WEST BUILDING ELEVATION | 1

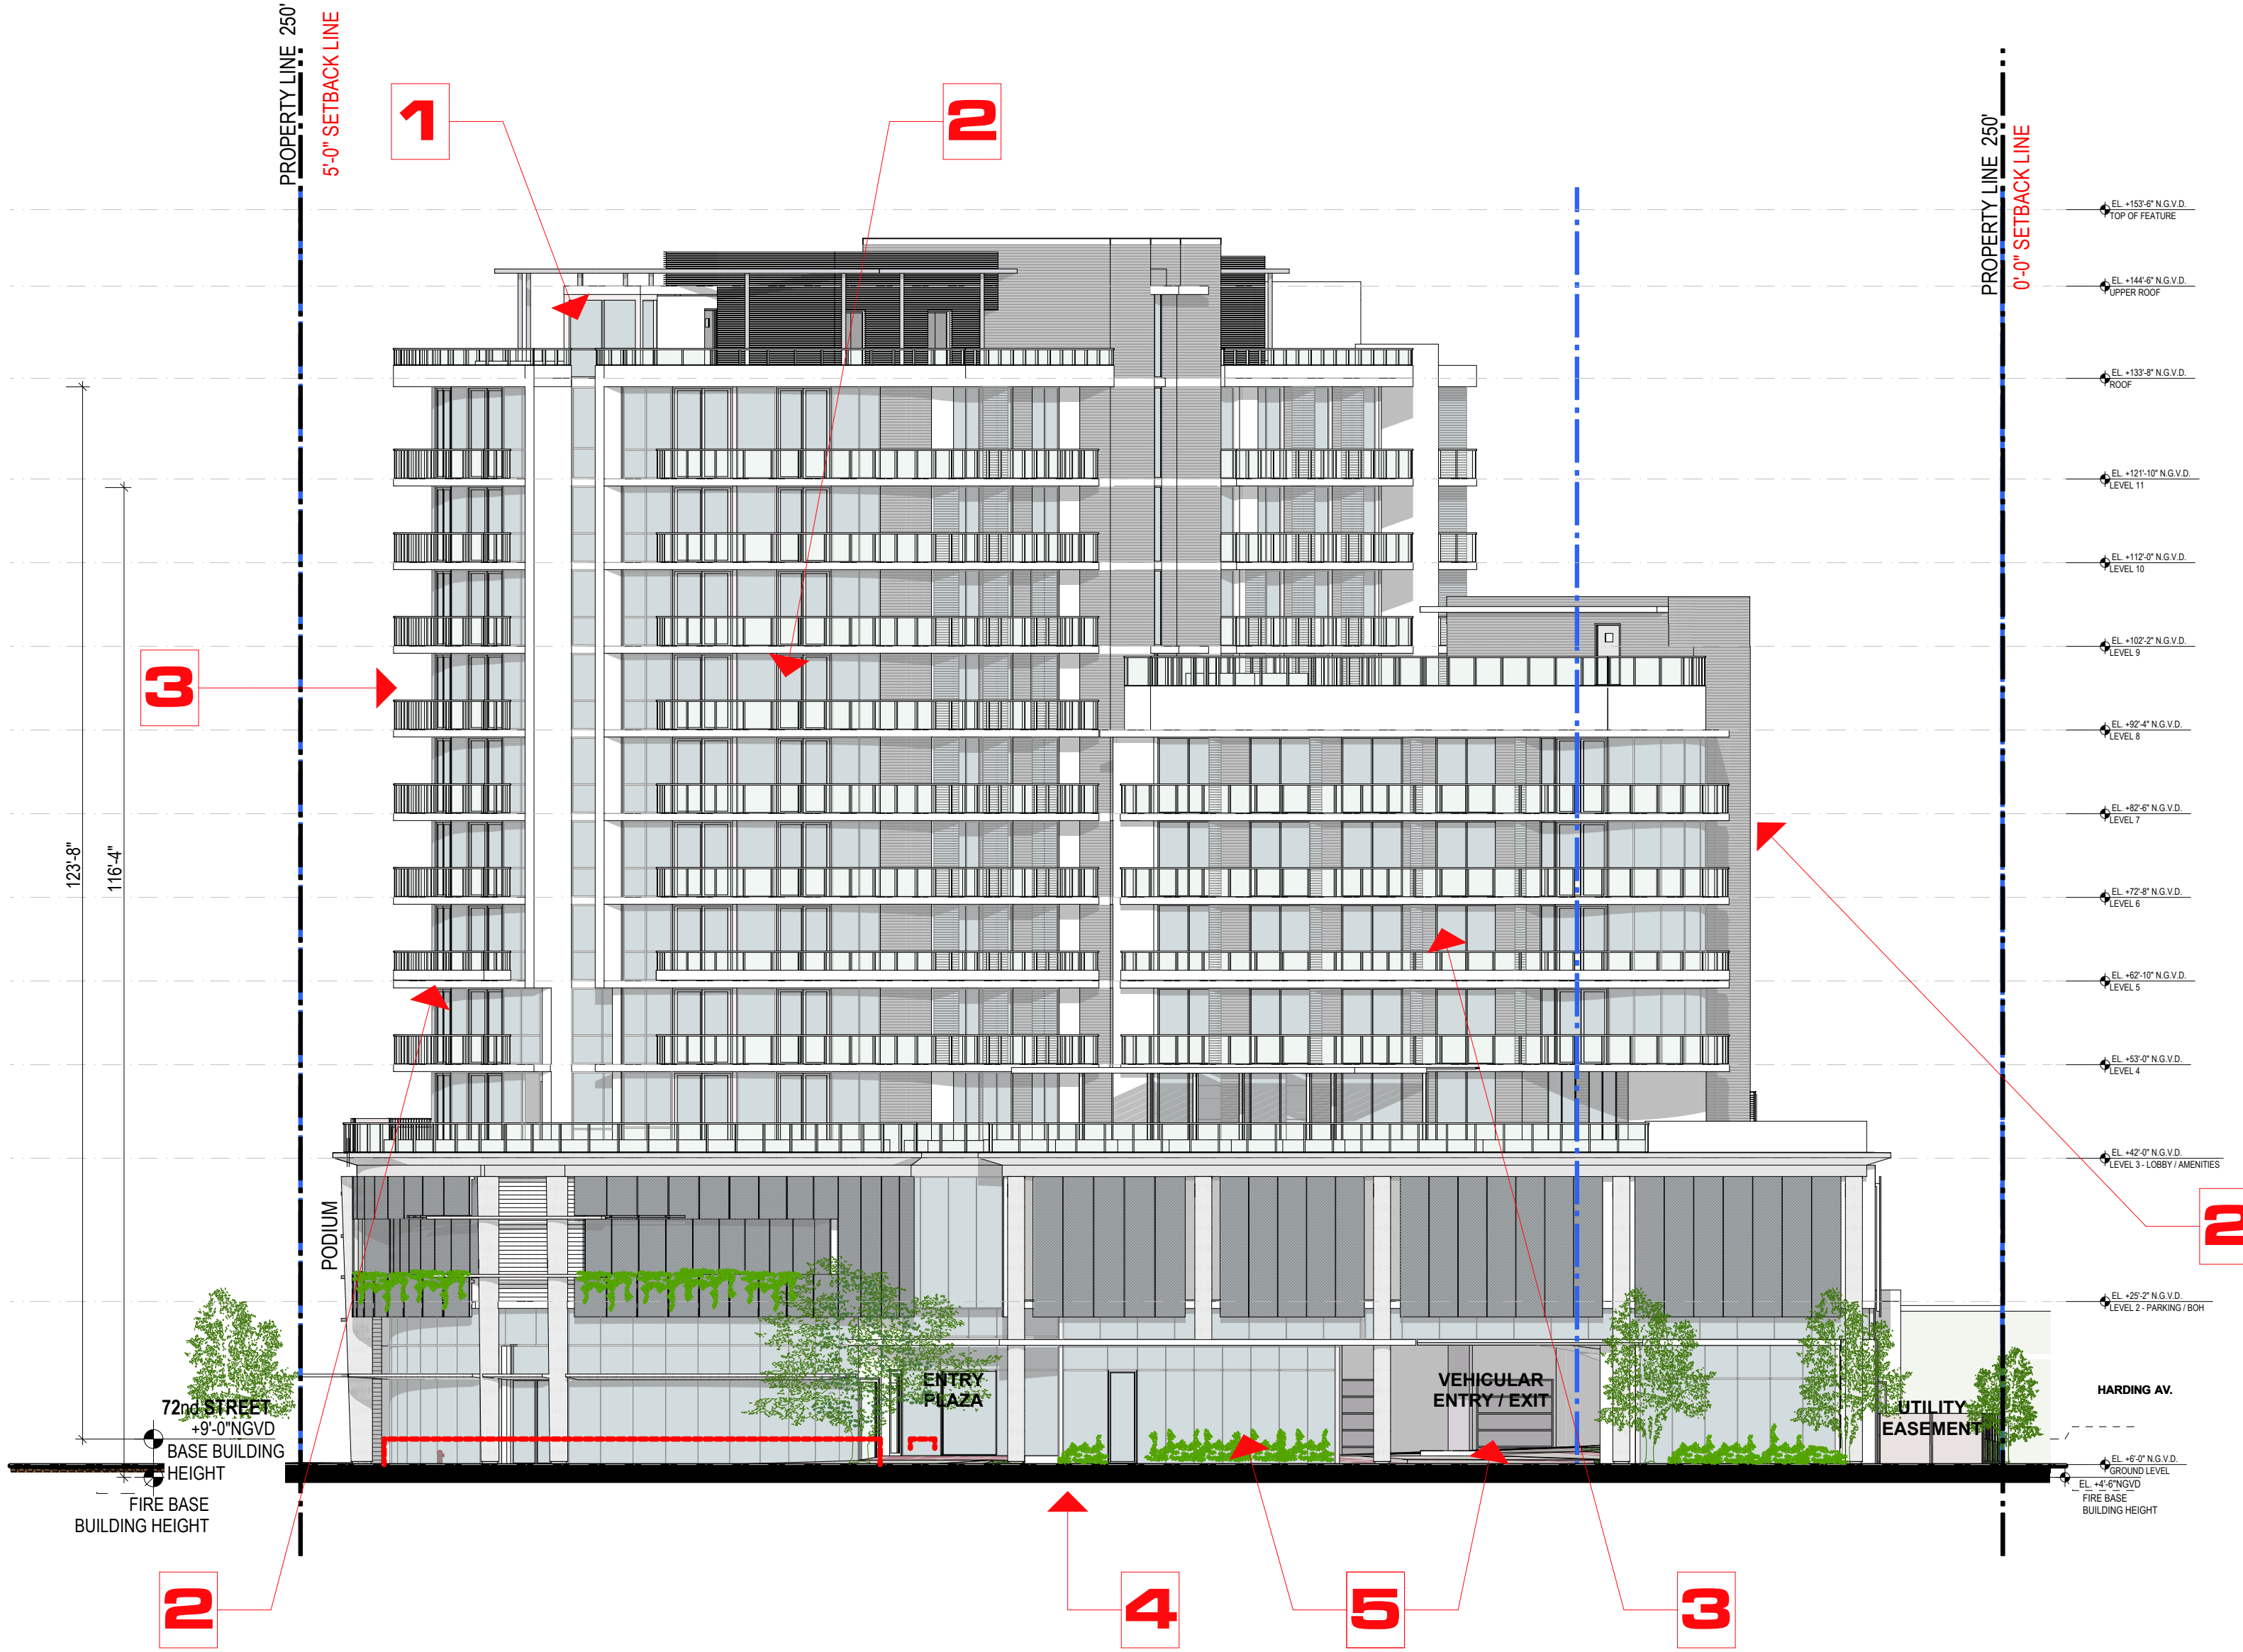
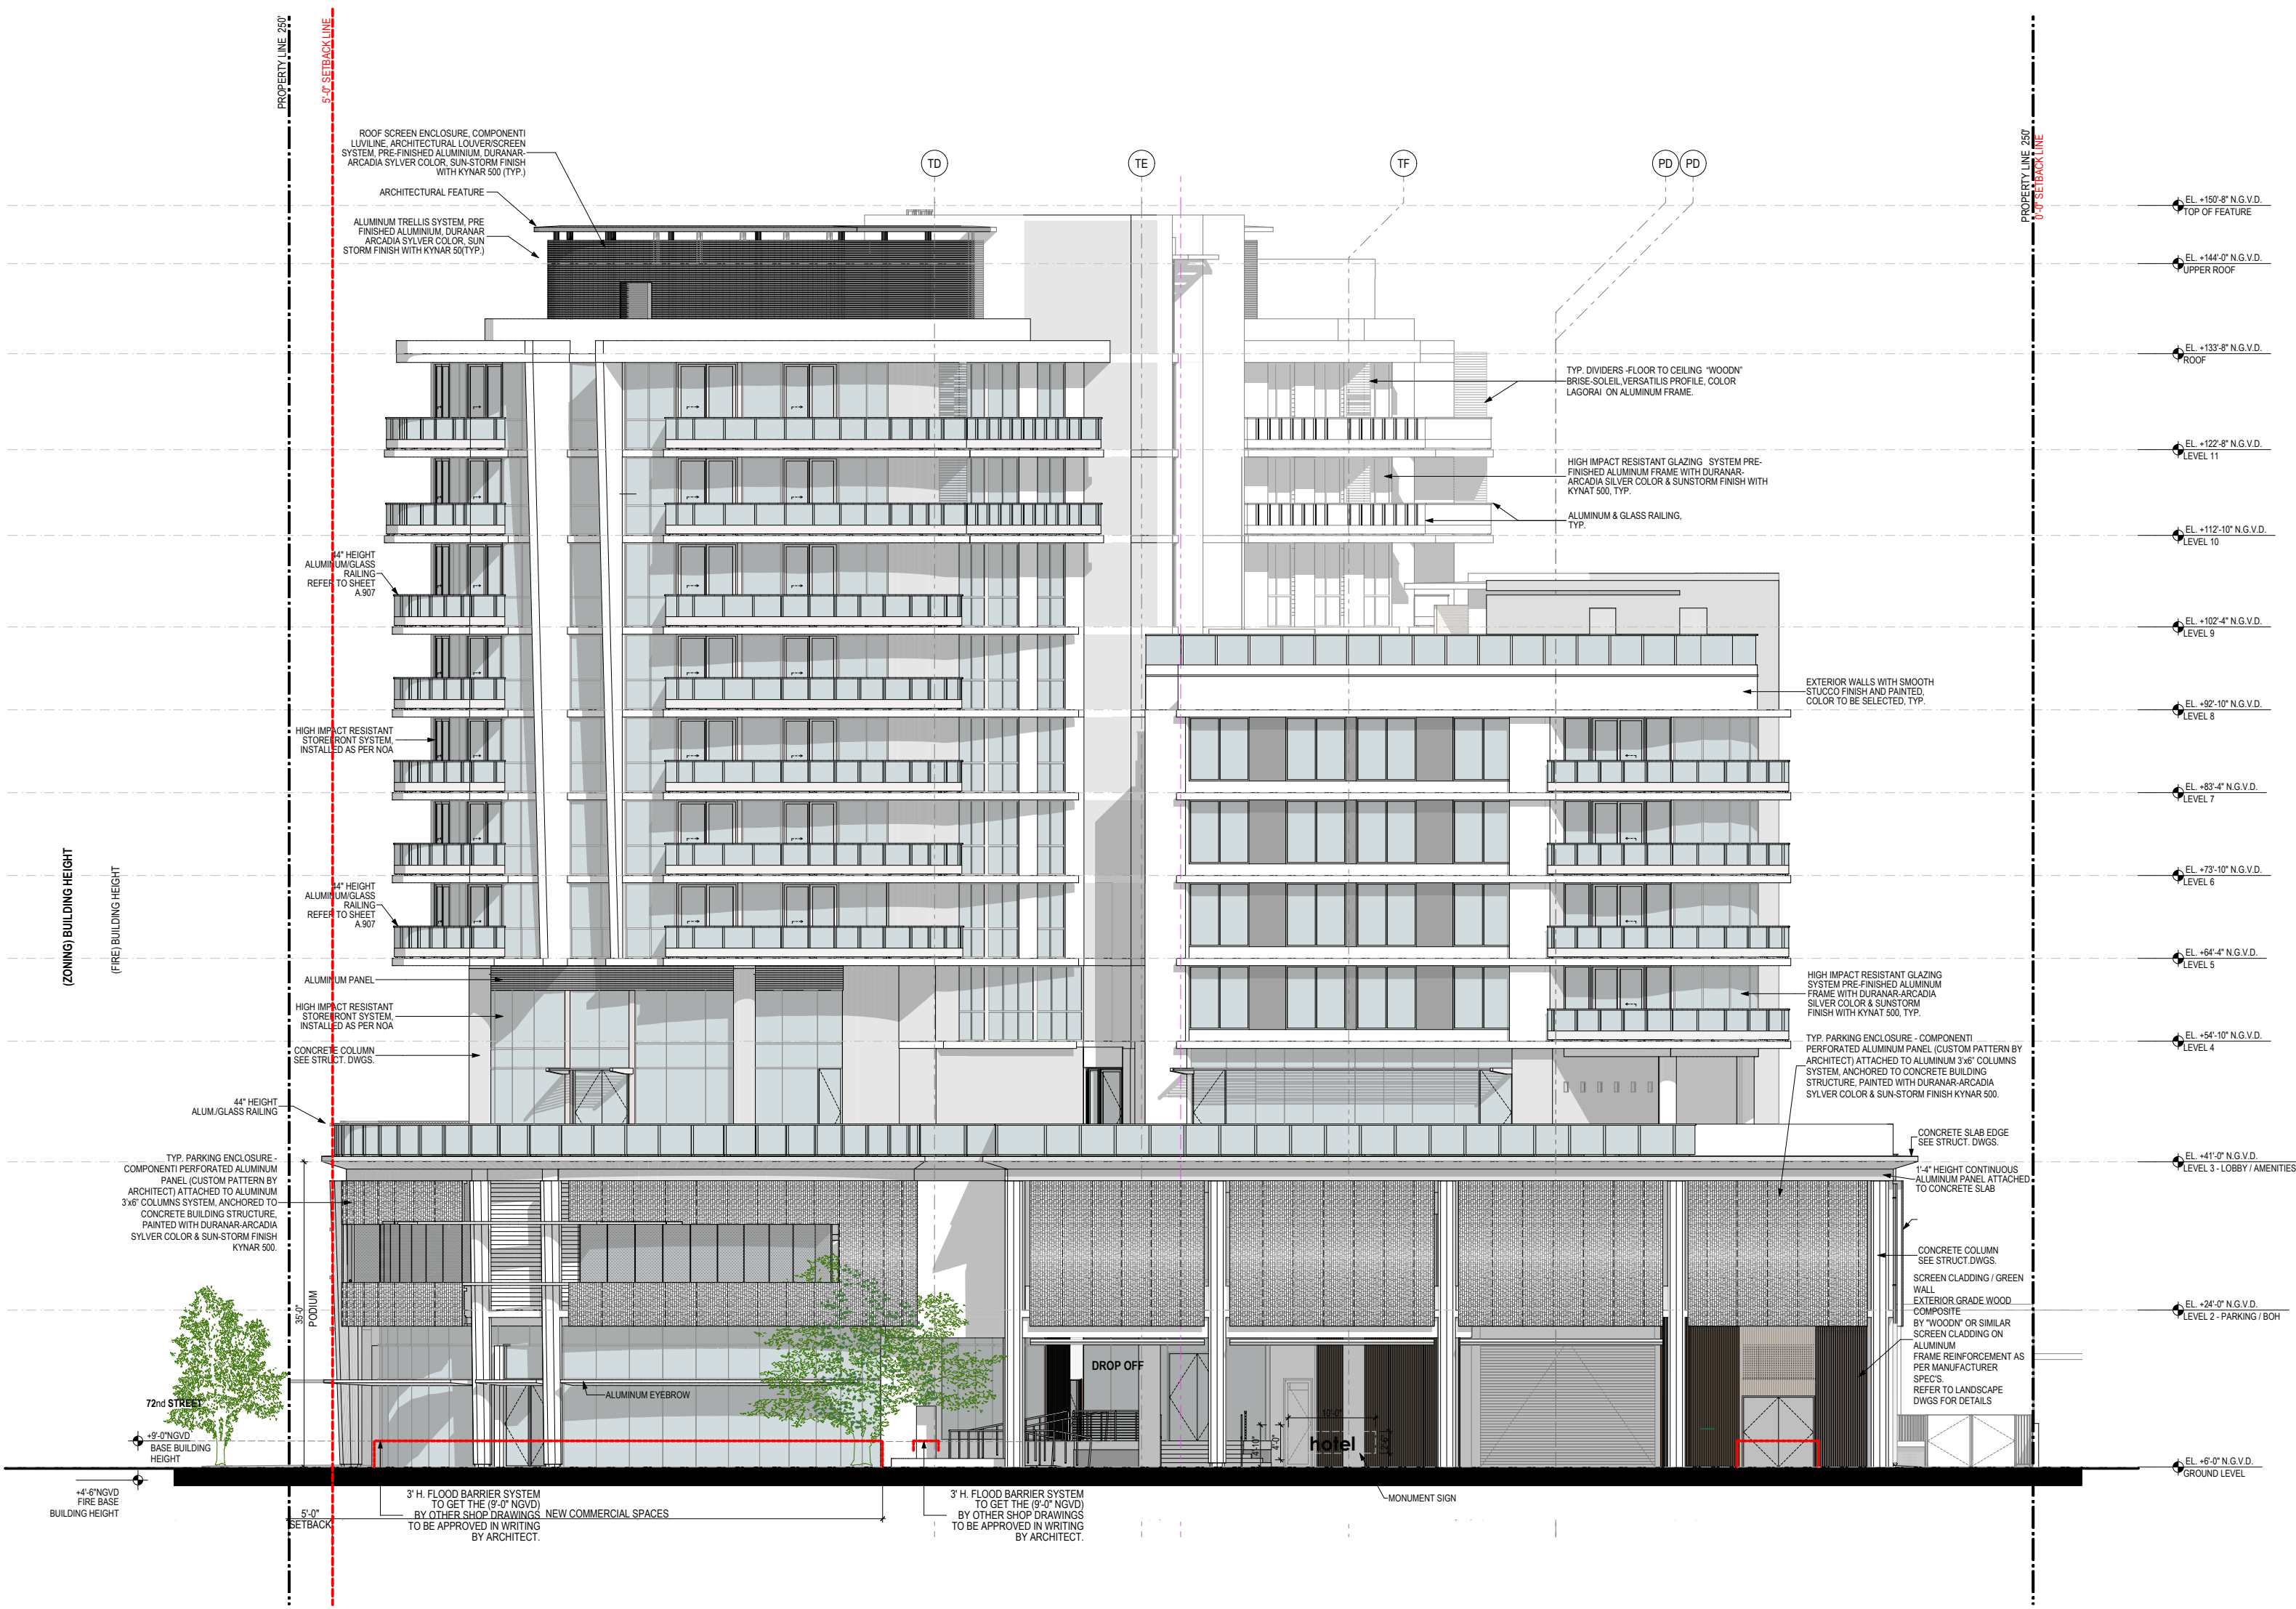
1. PROPOSED NEW ROOF-TOP
2. INTERIOR ORGANIZATION TO ACCOMMODATE CO-LIVING UNITS
3. REPLACING OF PREVIOUSLY APPROVED EYEBROWS BY BALCONIES AT NEW CO-LIVING UNITS
4. ELIMINATION OF A CURB-CUT TO MAXIMIZE ACTIVATED FRONT ON HARDING AND INTERNALIZATION OF THE VEHICULAR DROP-OFF
5. INTERNAL REORGANIZATION OF LOBBY AND LOADING AREAS
